Response to

Request for Additional Information No. 201, Supplement 3

U.S. EPR Standard Design Certification

QUESTIONS for Structural Engineering Branch 2 (ESBWR/ABWR Projects) (SEB2)

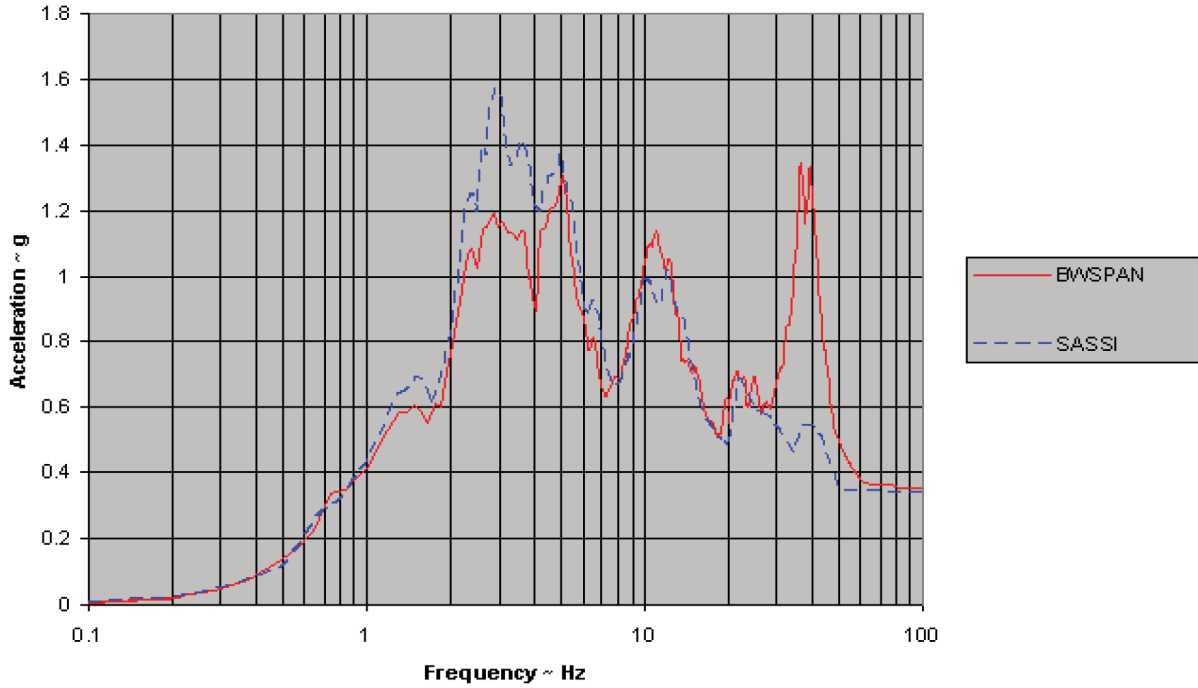
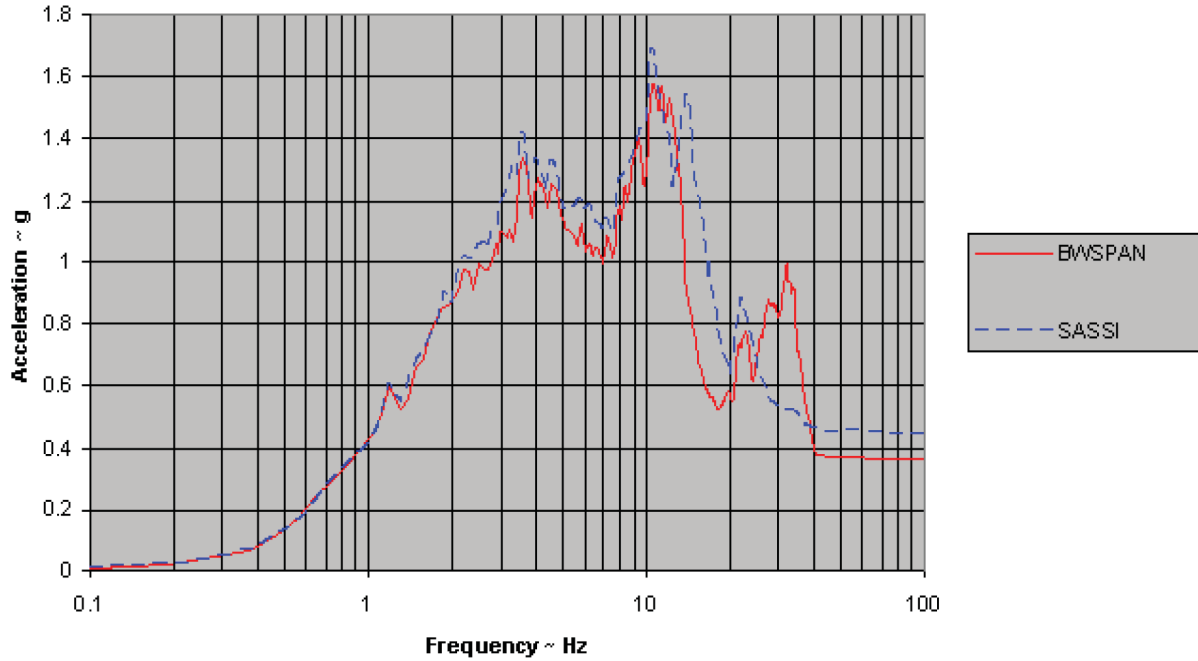
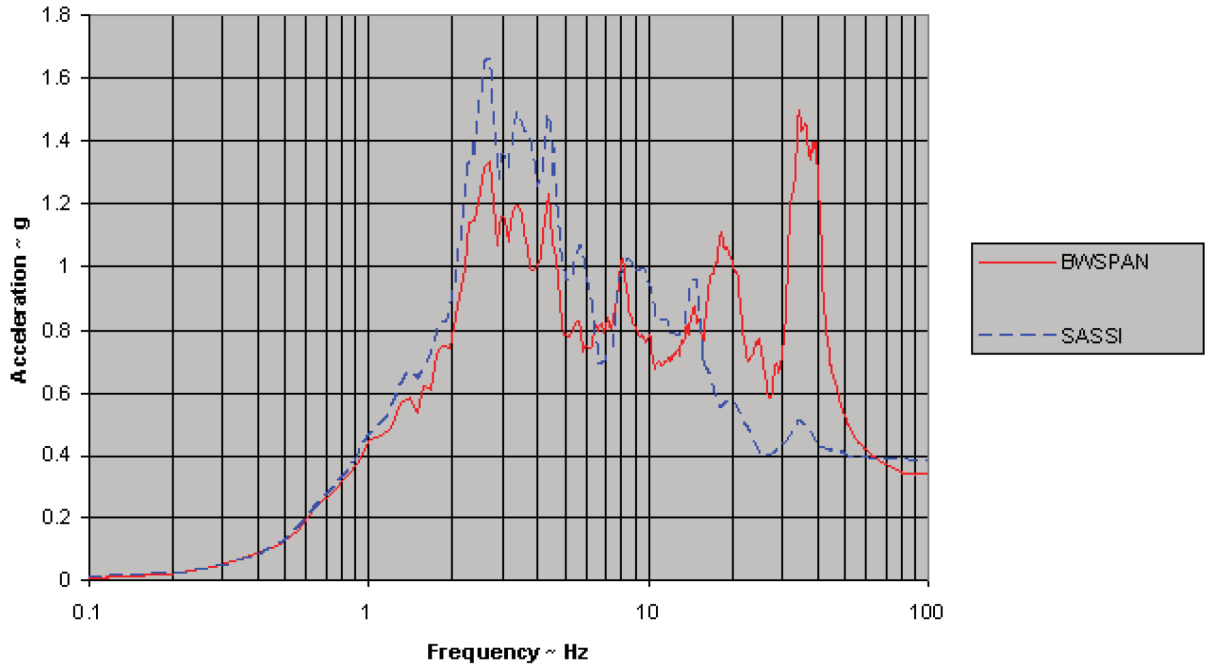
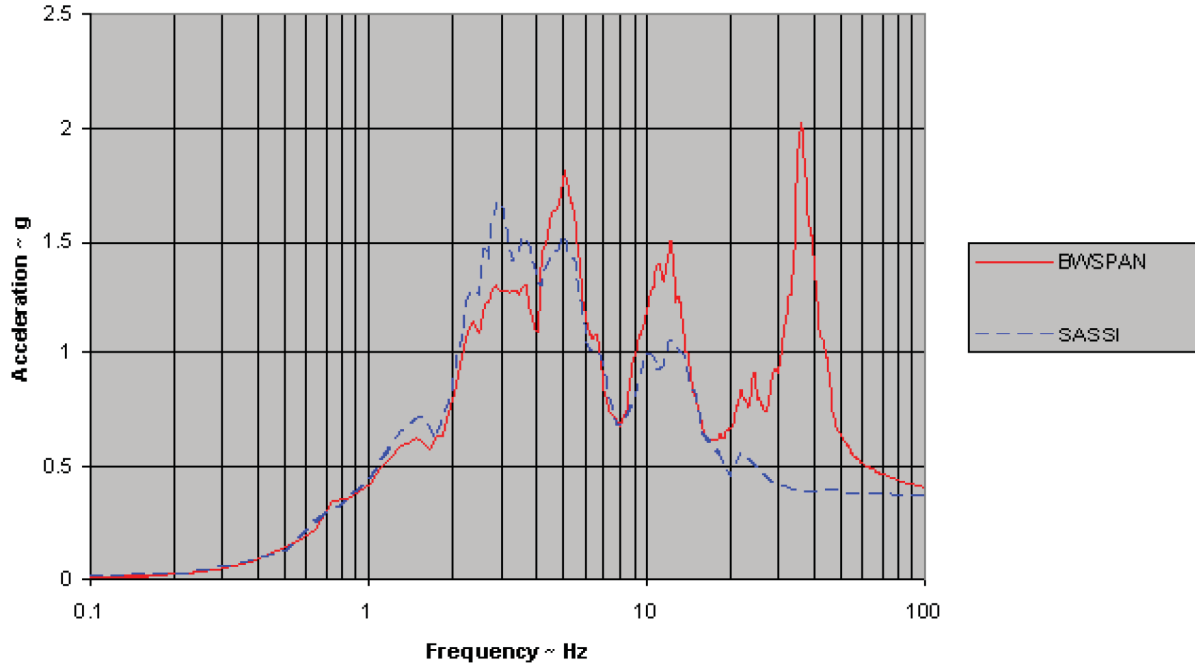
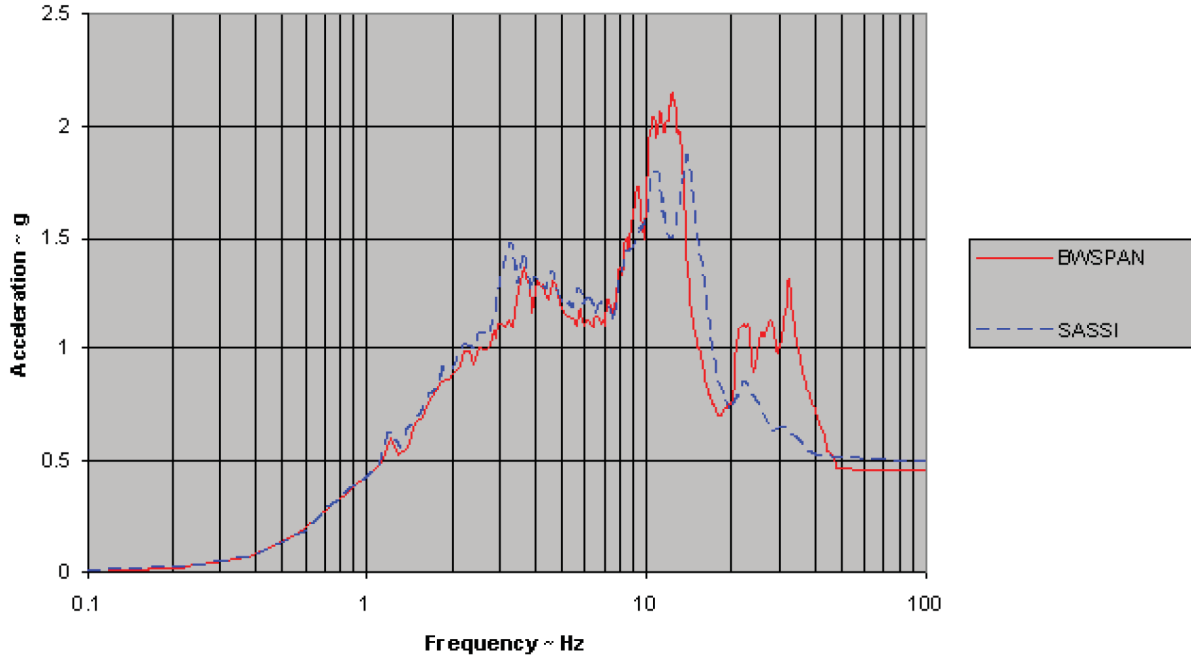
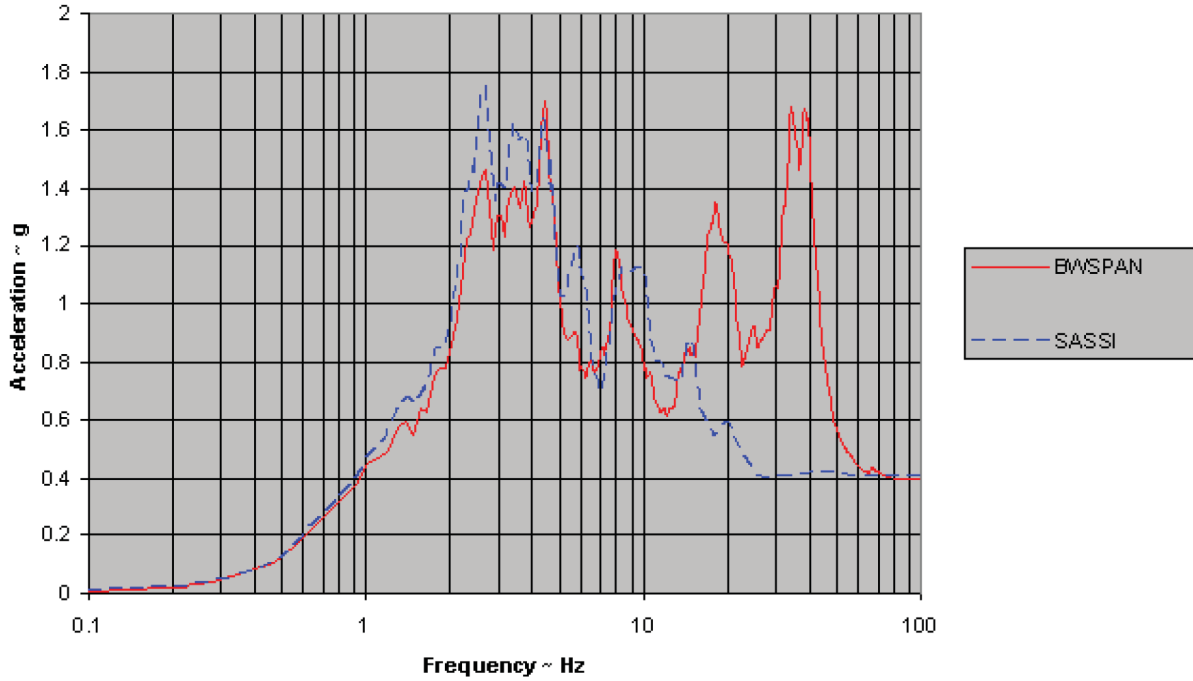
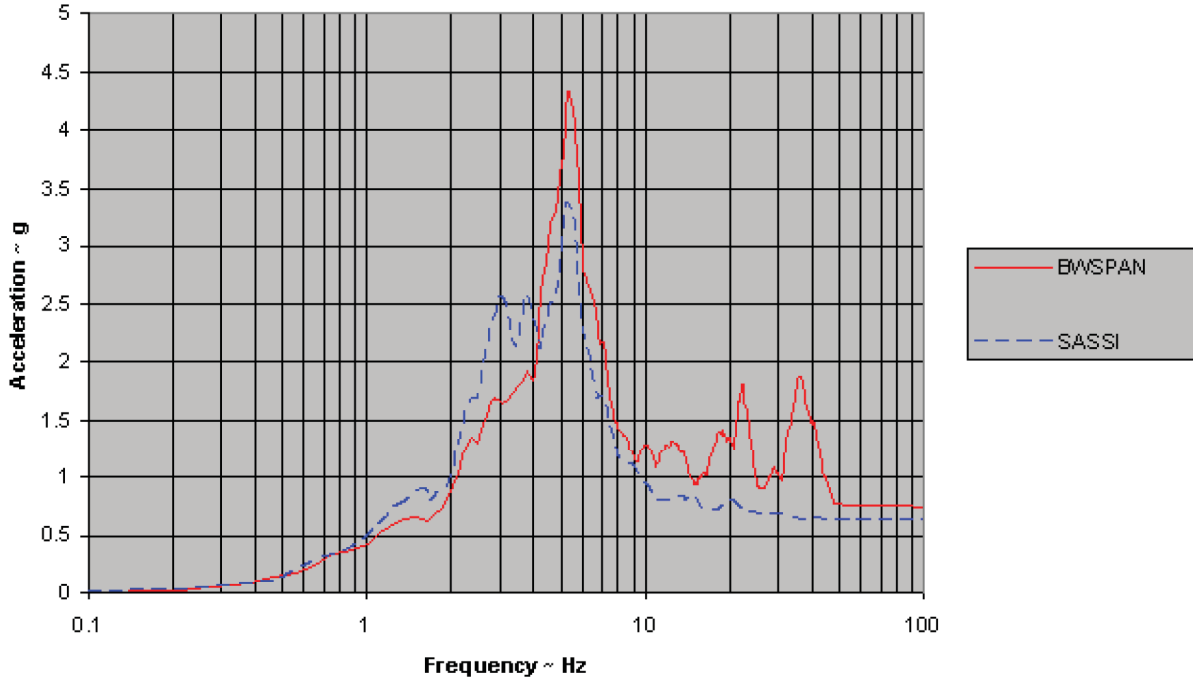
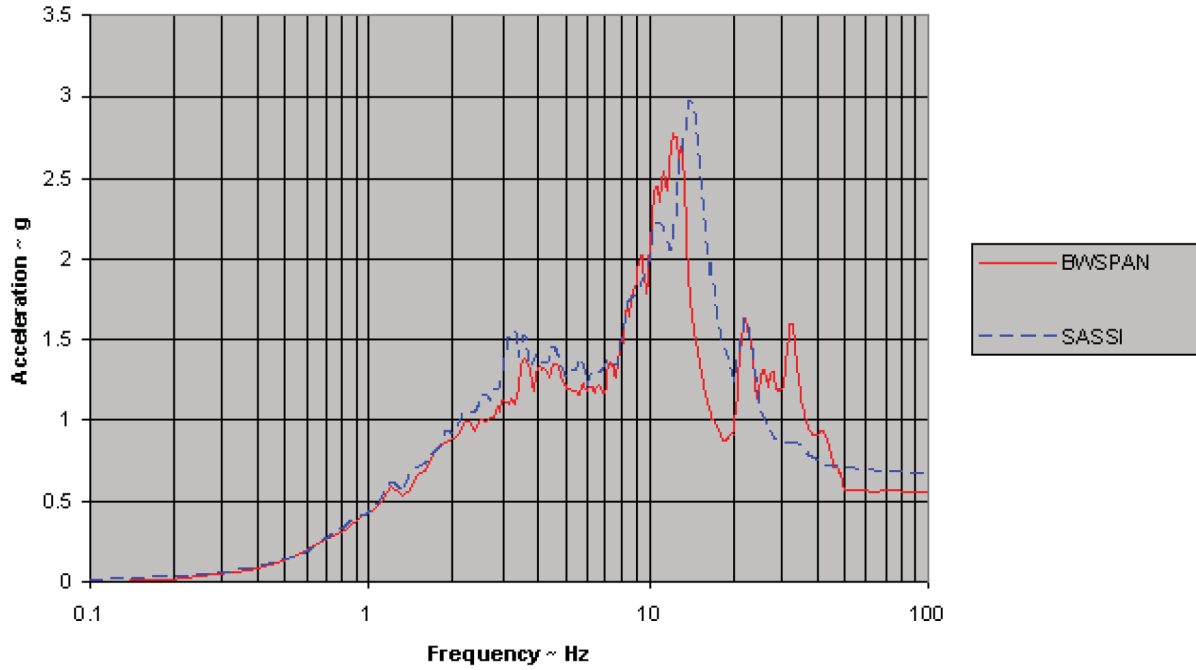
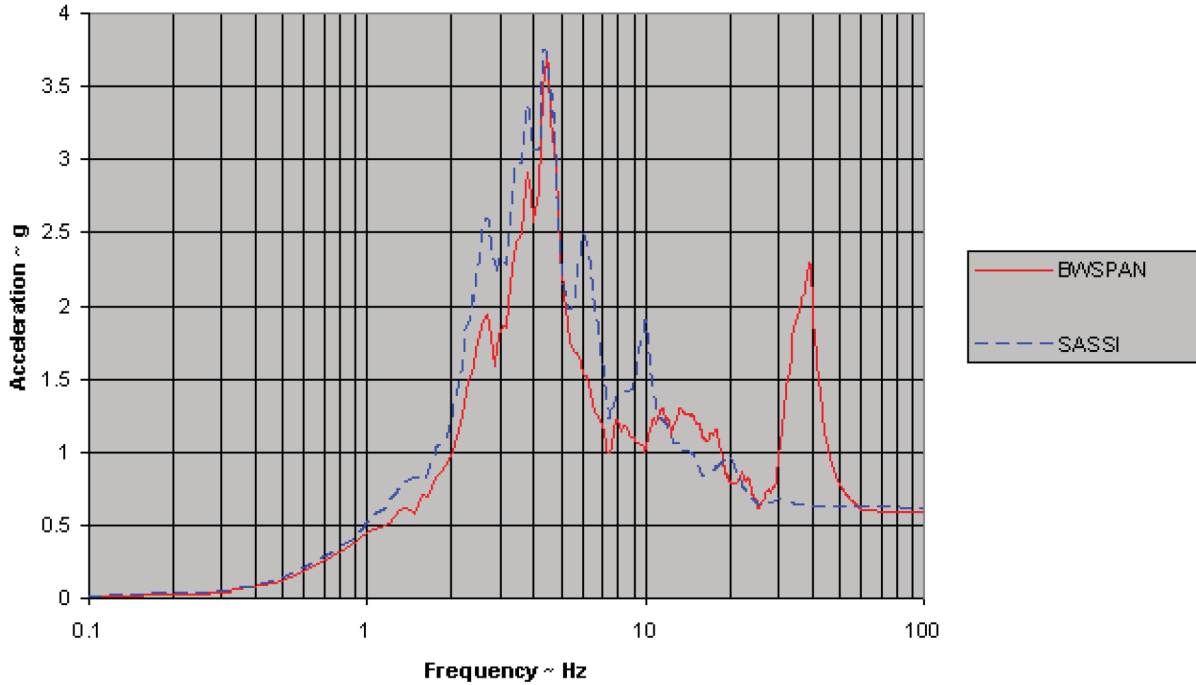
(Audit follow-up) Within the U.S. EPR standard design organization, one group is responsible for the seismic analysis of the NI common basemat structures and another group is responsible for the seismic analysis of the reactor coolant system (RCS). The NI seismic model contains a simplified model of the RCS provided by the group responsible for RCS seismic analysis. In a similar way, the seismic analysis of the RCS includes, in addition to a detailed model of the RCS, a seismic model of the Reactor Containment Building internal structure which supports the RCS. The seismic input for this coupled model consists of the time histories at the foundation mat determined from the NI seismic analysis. What are the methods used to verify that similar results are obtained in each of these analyses so as to verify that the interface forces are correct and that the coupled seismic model used in the analysis of the RCS is providing results consistent with the results obtained in the analysis of the NI common basemat structure? Include in your response a comparison of displacements and forces at key interface points of the RCS and internal structure from each of the models that document the adequacy of the results and methodology.

The enveloped acceleration response spectra generated from the RBIS SSI and RCS analyses of the seismic cases in U.S. EPR FSAR Tier 2, Table 3.7.1-6, including the high frequency (HF) cases are compared. Figures 3.7.2-35-1 to 3.7.2-35-9 show comparisons for the reactor coolant pump (RCP) and the lower steam generator supports (elevation 1.5 m), the reactor pressure vessel supports (elevation 5.15 m), and the upper steam generator supports (elevation 19.5 m). Comparisons of the acceleration response spectra generated from each analysis at the RCS support locations show that the responses of the two models are similar, except between 20-50 Hz. The relationship of these support locations to the RCS model is shown in Figure 3.7.2-35-10.

Figures 3.7.2-35-1 through 3.7.2-35-9 show that as a result of the HF case, the BWSPAN spectra exceed the SASSI spectra between 20-50 Hz. The differences in the in-structure response spectra (ISRS) at the locations shown are a result of:

- Differences in analysis techniques for the RBIS SSI analysis and the RCS seismic analysis of the RCS. The FEM model SSI analysis is performed in the frequency domain using MTR/SASSI. The RCS seismic analysis is performed with a BWSPAN time history analysis using modal superposition.
- Modeling limitations inherent in the creation of the simplified RBIS stick and RCS models, with the differences being amplified in the high frequency zone.

Below 20 Hz, the peaks result from fundamental modes of the structure-soil system. The magnitudes and frequencies are expected to be different as a result of the simplifications in both models. The BWSPAN spectra for wall locations are prepared for comparison purposes only.
